TECHNICAL NOTE

Project	Kidderpore Avenue
Report Title	Non Material Amendment (S96a) – Hampstead Manor Vehicular Access
Date	21/06/2017
Prepared by	Phil Wilson
Checked by	Derek Griffiths
Approved by	Roy McGowan
Prepared for	Mount Anvil

Figure 1.3: Amended layout of the basement access

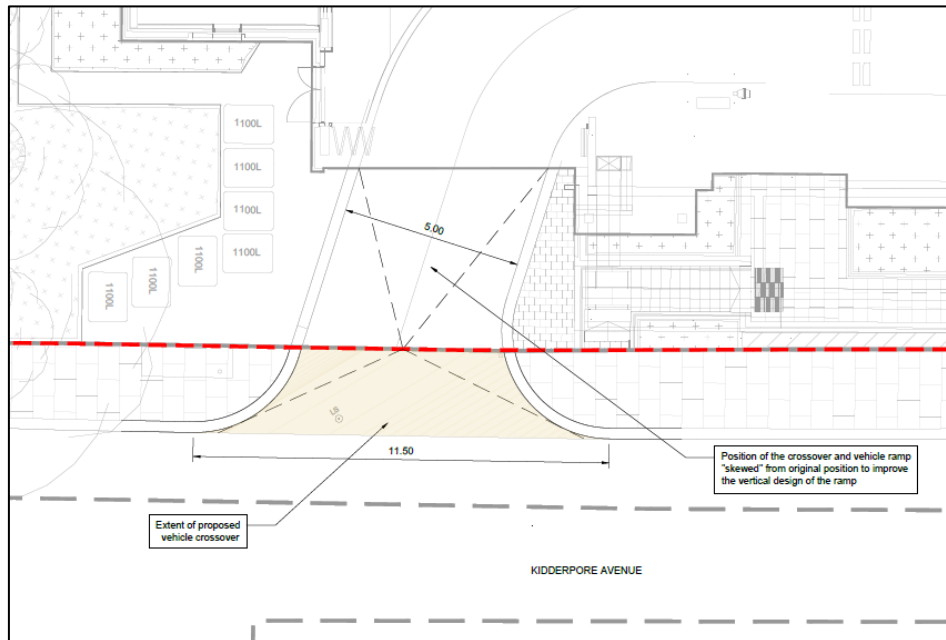
- 1.3.2 At a design team meeting in November 2016 it was highlighted the proposed layout of the ramp (in its current position) would result in substandard vertical geometry resulting in vehicle grounding and steep gradients. The team therefore agreed to “skew” the position of the ramp, to increase the length of the approach ramp and flatten the general profile ramp improving its vertical geometry.

- 1.3.3 The design was discussed with Camden’s highway and planning team on 02/03/2017, where the principles of the layout were agreed. The revised layout is shown in figure 1.3. The following drawings provide further details in Appendix A.

Figure 1.4: Root protection area

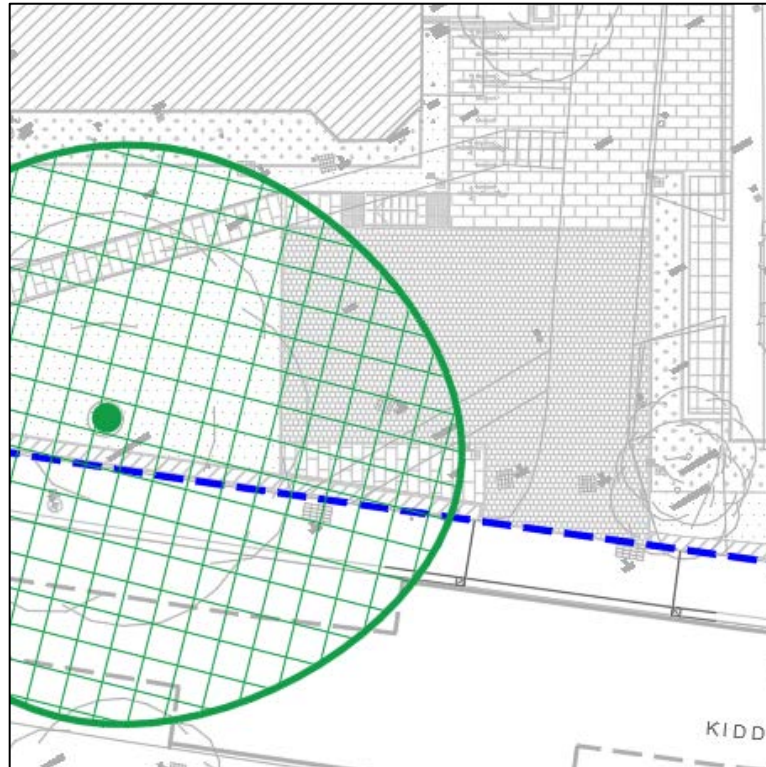
- 1.4.1 To cater for deliveries to the development provision was made for an off-street delivery and servicing area accessible from the existing eastern vehicle access to the site. This delivery and servicing area was originally planned to accommodate two bays for vehicles up to 7m in length.
- 1.4.2 During the detailed design of the area, it was highlighted that the proposed servicing area conflicted with the root protection zone of a nearby tree shown in figure 1.4. The tree is covered by an LBC Tree Preservation order which prevents the cutting of roots without the specific permission of LBC.

Figure 1.4: Amended layout of Lord Cameron Hall Access

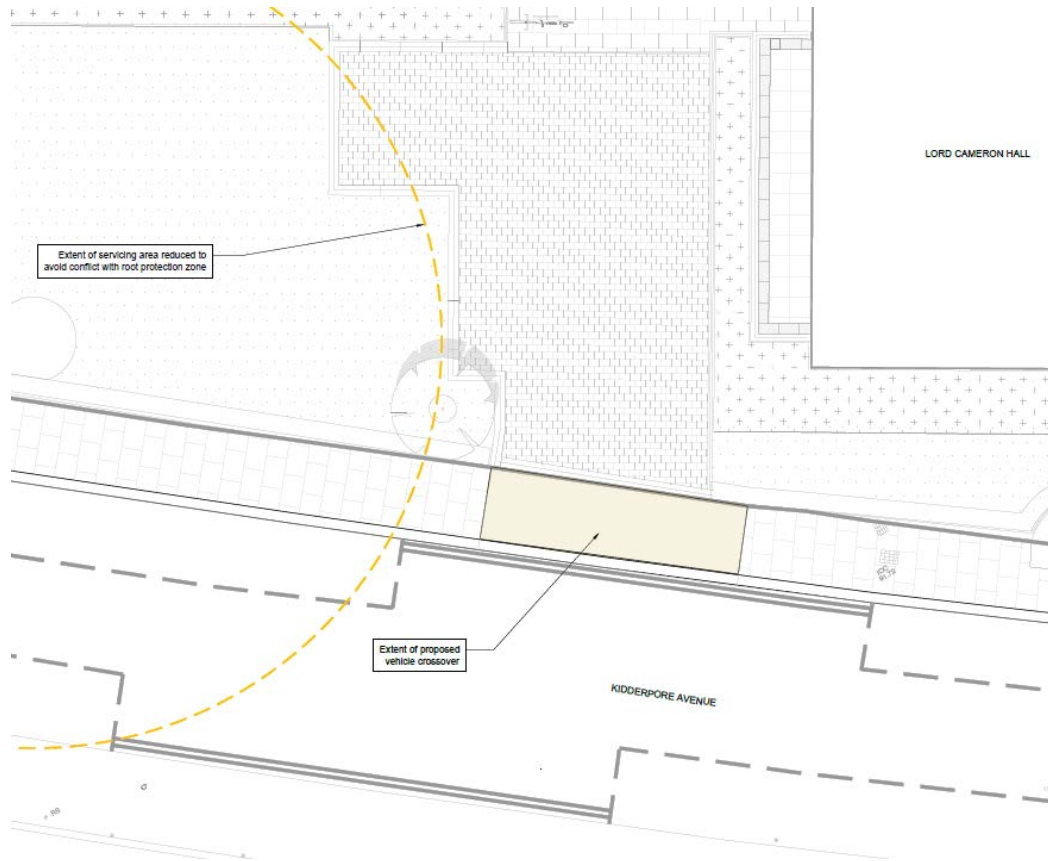
- 1.4.4 Option 1 proposed the reduction of the proposed hardstanding area to minimise encroachment into the root protection area. Two loading bays are no longer achievable with this option and a small turning head is included in place so that vehicles can still enter and exit in forward gear.

- 1.4.5 The arrangement requires a small section of the root zone to be cut into, however trial holes (available on request) undertaken recently on behalf of the Landscape Architect (Fabrik). showed that there is little evidence of root growth in this area.

- 1.4.6 The revised design is shown in figure 1.5 below, the following drawings provide further details in Appendix B

Figure 1.4: Root protection area

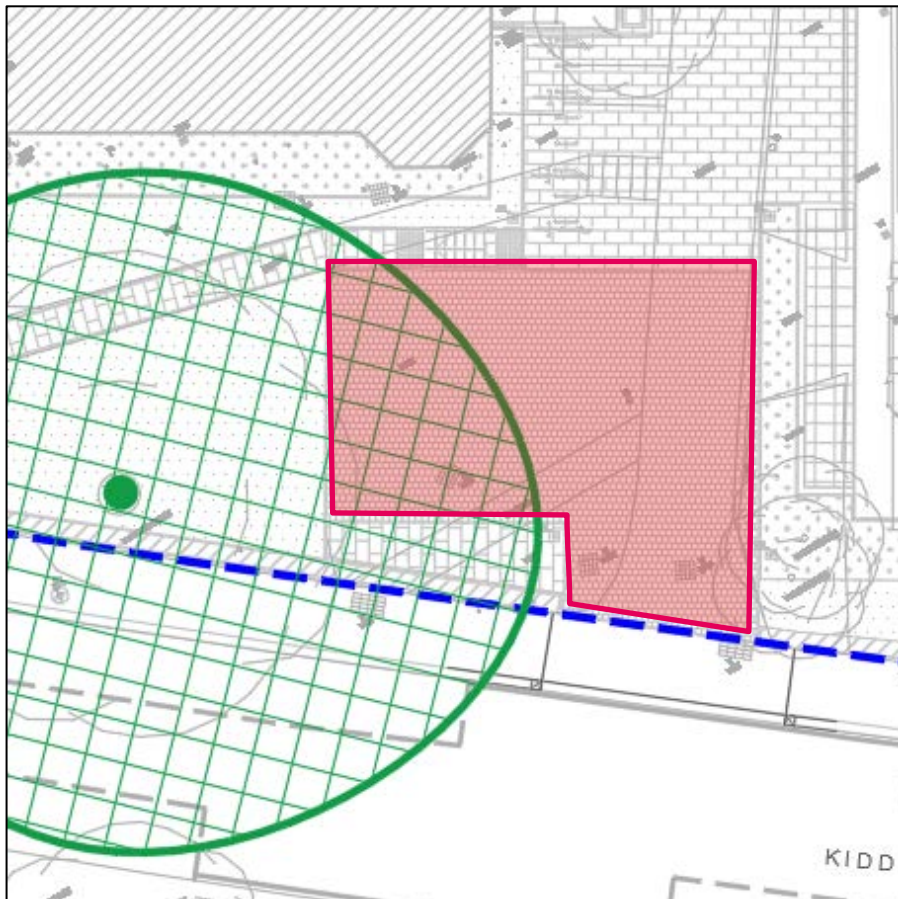
- 1.2.8 The estimated root zone of the tree is shown in green hatching in Figure 1.4, and it can be seen that the zone clashes with the proposed loading bays.

- 1.2.9 MTP and Fabrik have undertaken a review of the levels within the site to determine how the loading bay could be raised to a level that would allow for a 'no dig' solution that would minimise the impact on the tree roots (albeit increasing the potential impact of high sided vehicles on the tree canopy). This analysis has shown that any hardstanding in this area would be required to be lower than the existing levels to tie into the existing access whilst achieving acceptable gradients across the area.
- 1.2.10 As a result of this analysis, it is considered that this option is no longer viable without detriment to the tree. As such, we have considered potential alternative approaches to allow for servicing and deliveries.

Figure 1.5: Option 1

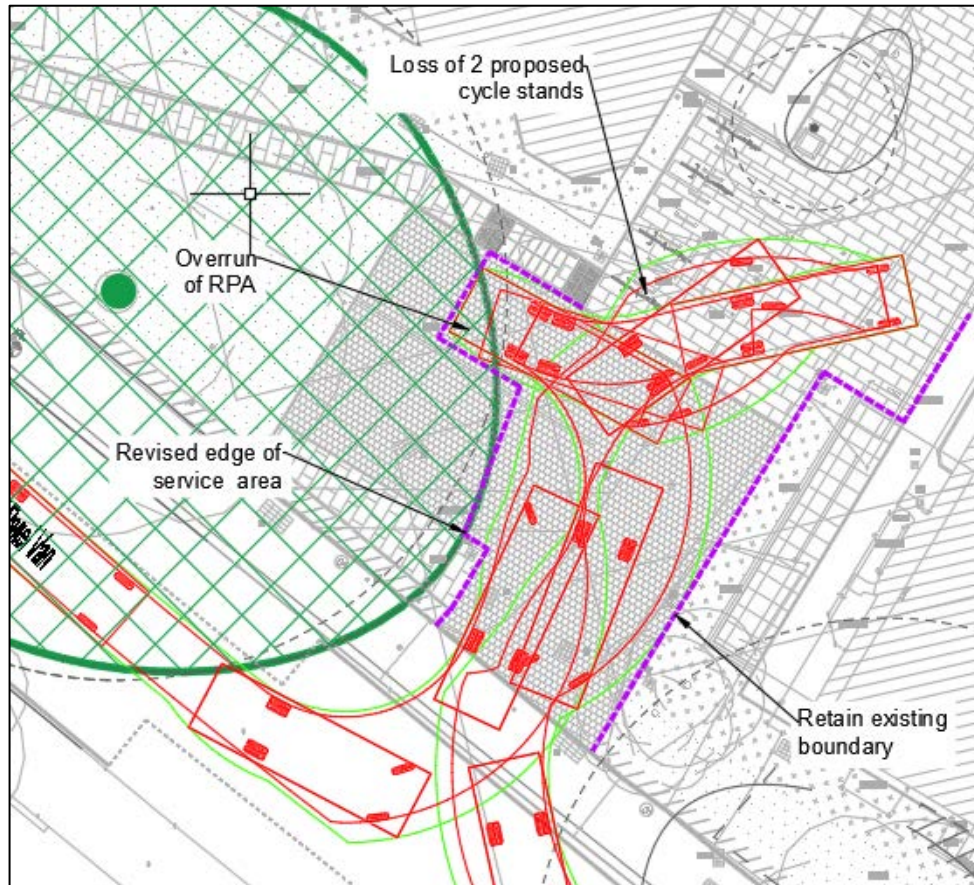
- 1.3.1 Option 1, shown in figure 1.5, proposes the reduction of the proposed hardstanding area to minimise encroachment into the root protection area. The two loading bays are no longer achievable with this option with a small turning head included instead so that vehicles can still enter and exit in forward gear.
- 1.3.2 The reduction in space with this arrangement means only one delivery vehicle can access the area at a time, and were two vehicles to arrive at the same time, one would be required to wait on street. The tighter turning movements also mean at least two of the proposed cycle stands would need to be relocated.
- 1.3.3 The arrangement requires a small section of the root zone to be cut into, however trial holes undertaken recently to inform Fabrik's work show that there is little evidence of root growth in this area.

- 1.7.2 Option 1 significantly reduces (but does not eliminate) the impact on the tree relative to the current proposal. Whilst it reduces the level of on-site service vehicle provision from two to one spaces, it retains forward in – forward out access.

Figure 1.6: Option 2

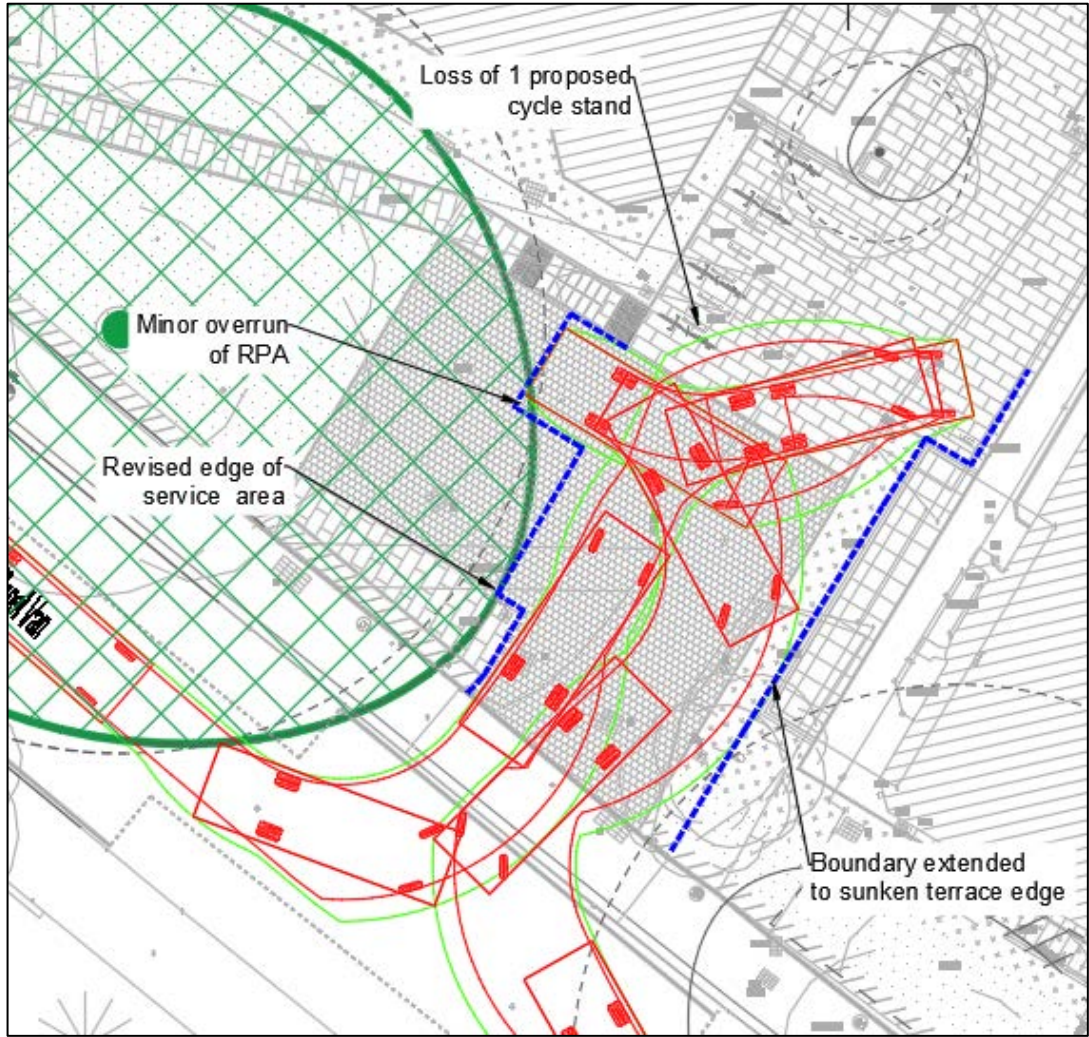
- 1.4.1 Option 2, shown in figure 1.6, is similar to option 1 and proposes the reduction of the proposed hardstanding area to minimise encroachment into the root protection area. The hardstanding area is instead expanded on the east side to the edge of the proposed building terrace. By doing so a smaller section of the root protection area is cut into.

- 1.4.2 As with option 1 the two loading bays are no longer achievable with this option with a small turning head included instead so that vehicles can still enter and exit in forward gear.

- 1.4.3 The reduction in space with this arrangement means that only one delivery vehicle can access the area at a time. Additional vehicles will be required to wait on street. The tighter turning movements also mean at least one of the proposed cycle stands will need to be relocated to facilitate turning movements.

- 1.4.4 It is also noted that the landscape architect feels the loss of the landscaping on the southeastern edge would be detrimental to the wider landscaping scheme.

- 1.7.3 Whilst Option 2 further reduces the impact of development within the tree root protection zone, the expansion to the hardstanding area shown in option 2 affects the wider layout of the proposed development and the architect has expressed a desire to not pursue this option further. The option provides broadly the same level of service as Option 1.

Figure 1.7: Option 3

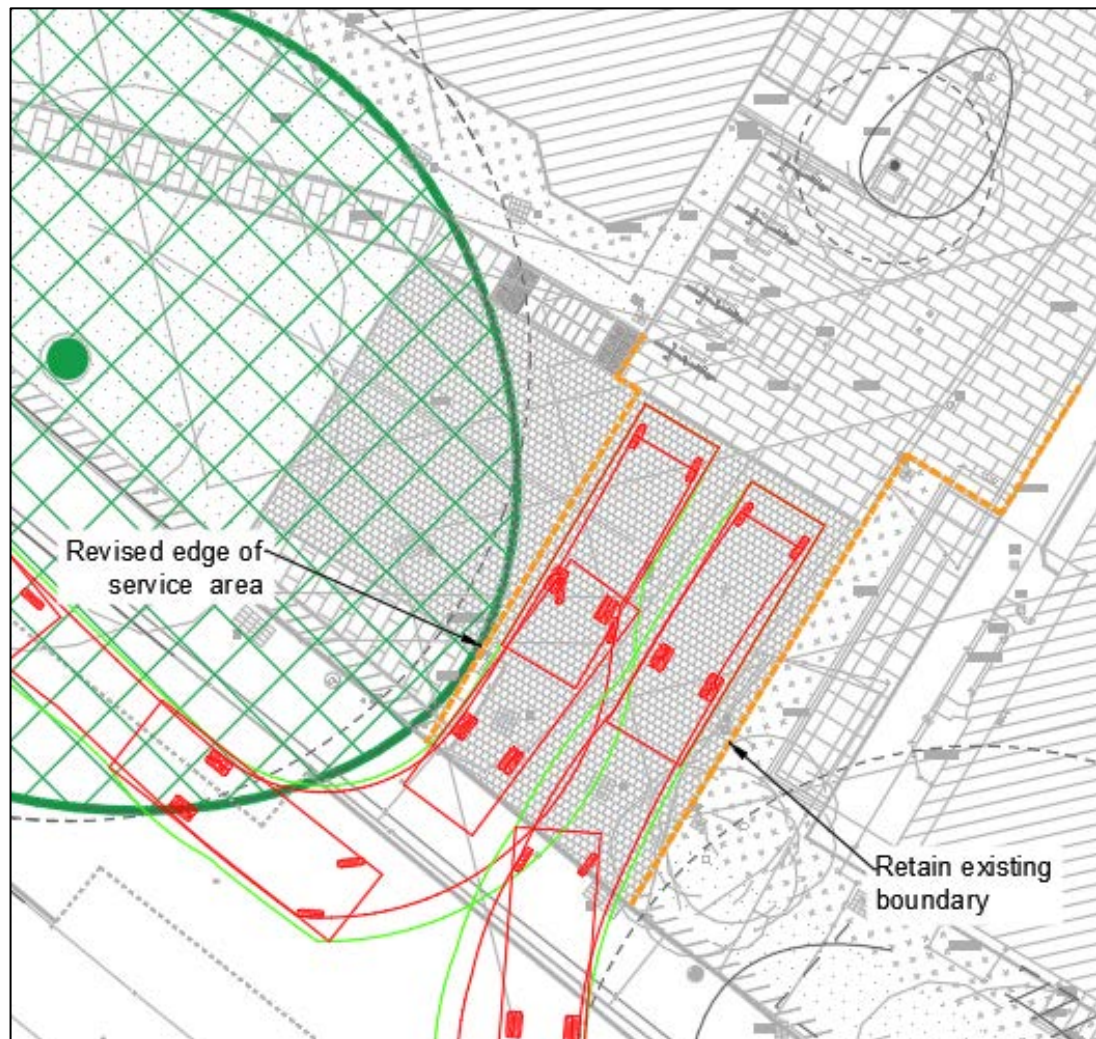
- 1.5.1 Option 3, shown in figure 1.7, proposes the reduction of the proposed hardstanding area to remove any encroachment into the root protection area.

- 1.5.2 The original two parallel loading bays are no longer achievable with this option. Instead the entrance is widened on the west side so that two bays be provided perpendicular to Kidderpore Avenue. No turning head is provided so vehicles would be required to either enter or exit in reverse gear. In addition, when being used by two vehicles simultaneously the access would block access for emergency vehicles. There would be no impact on the cycle bays in their current positions.

- 1.5.3 MTP's previous work highlighted concerns that given the level of pedestrian traffic along Kidderpore Avenue, including to and from local schools, would increase the risk of vehicle / pedestrian conflict, and also vehicle / vehicle conflict as a result of reversing manoeuvres from or back to the carriageway. Such issues would need to be fully assessed should this option be progressed further.

- 1.7.4 The adverse vehicle movements associated with option 3 (vehicles reversing across the footway) mean the option is less likely to be acceptable on safety grounds, whilst it also contradicts the client's original brief for the scheme. It does however remove the impact on the tree root protection zone.
